# Duquesne Light

SUBJECT: Beaver Valley Power Station - Unit No. 2  
Docket No. 50-412  
Responses to NRC Structural Engineering Section Requests for  
Additional Information

Attached are the responses to the NRC Structural Engineering  
Section's Questions 220.13 and 220.14, which are related to NRC Structural  
Design Audit Action Item 25.

FIGURE 220.14-1  
RACK STRUCTURE  
BEAVER VALLEY POWER STATION - UNIT 2  
FINAL SAFETY ANALYSIS REPORT

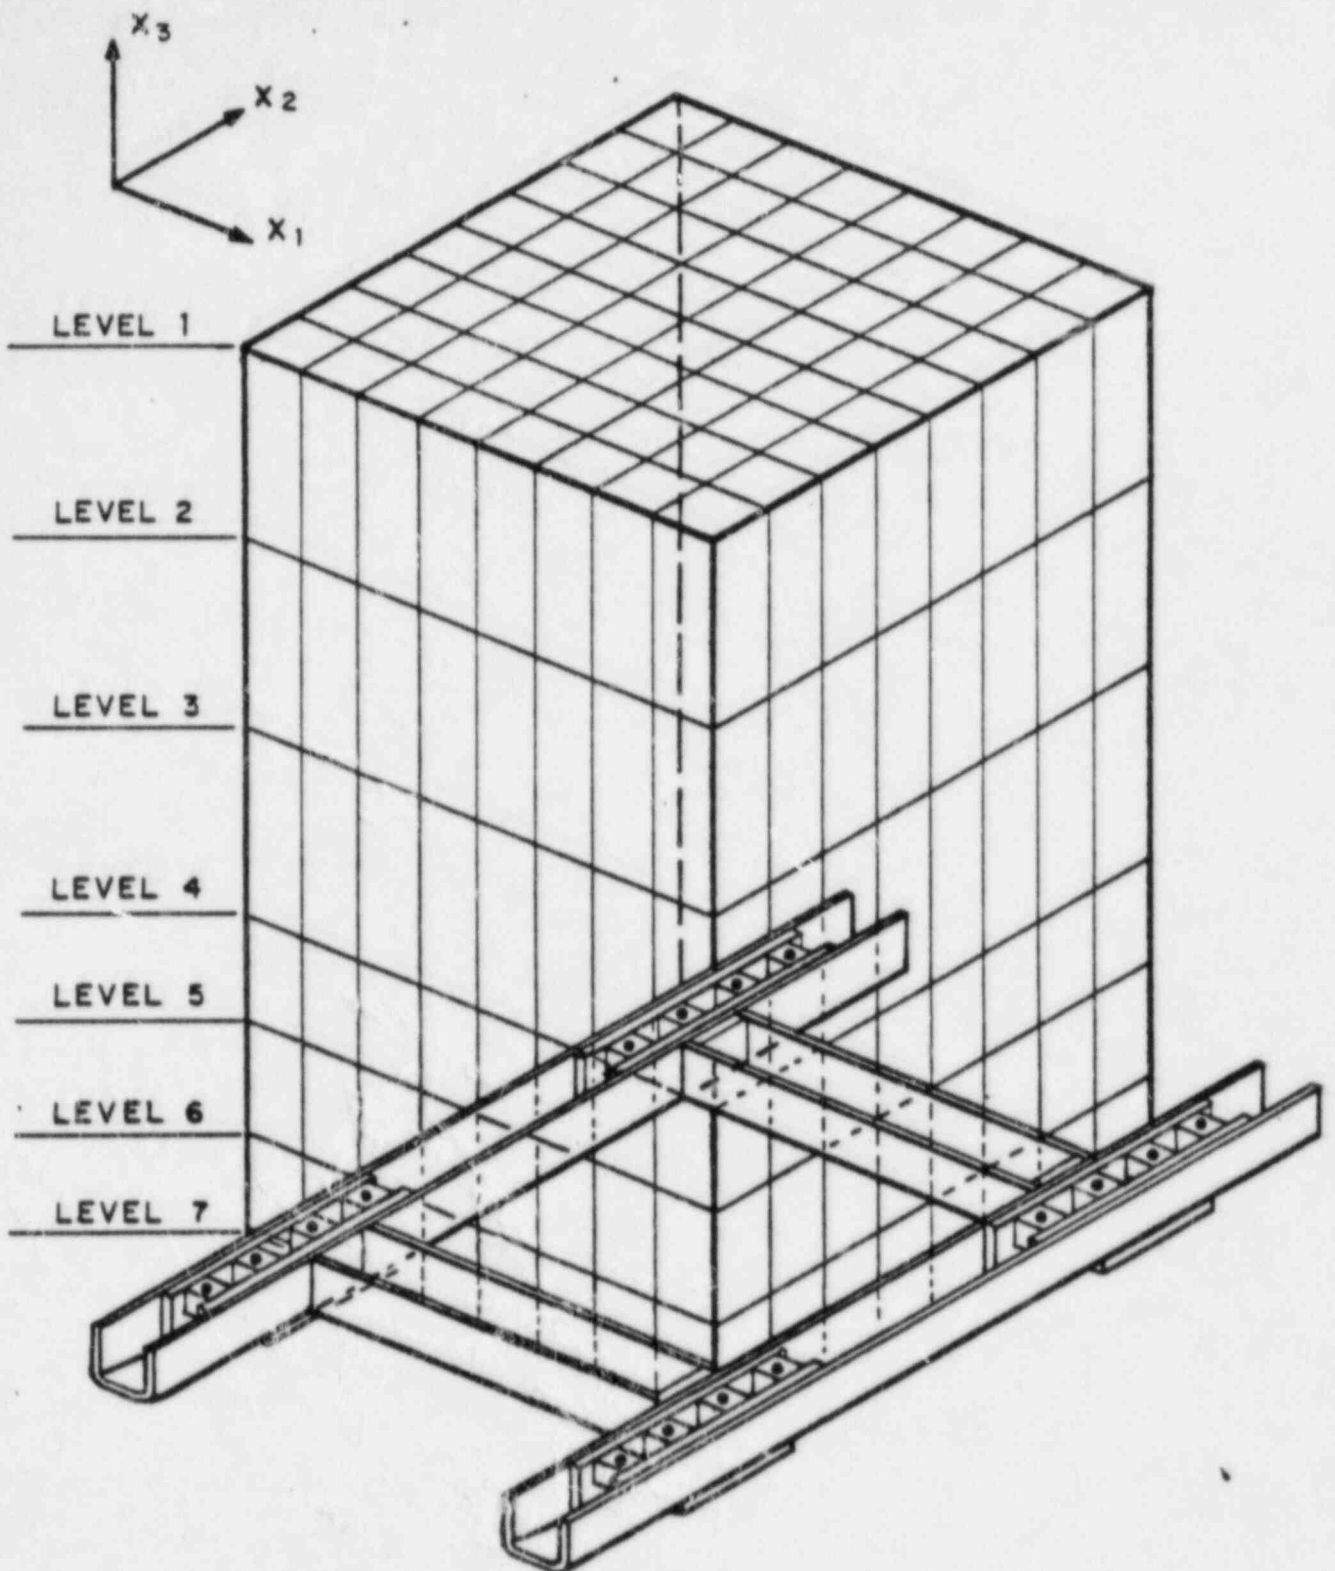
Provide the sketches of the mathematical models used in the design of spent fuel racks. Describe the methods of analysis, boundary conditions, spring-mass locations, fluid modeling and damping considerations. Also describe the methods by which seismic and other loads are applied to the racks and the pool.

In order to perform static stress analyses of the fuel storage rack structure, the rack has been mathematically modeled as a finite element structure consisting of discrete three-dimensional elastic plate elements interconnected at a finite number of points using the ANSYS computer program. The stiffness characteristics of the structural members are related to the plate thickness, cross-sectional area, effective shear area, and moment of inertia of the element section. To take advantage of the symmetry of the structure

and loading conditions, only one-half of the rack was modeled, with the plane of symmetry located on the center line of the rack. All nodes in the plane of symmetry were restrained for translation in the horizontal  $X_2$  direction and for rotation about the  $X_1$  and  $X_3$  axes. Six degrees of freedom (three translations and three rotations) are permitted at each of the remaining nodal points. Figure 220.14-1 illustrates the model. Pinned boundary conditions were applied at each location where the rack base plate is connected to the base beam system.
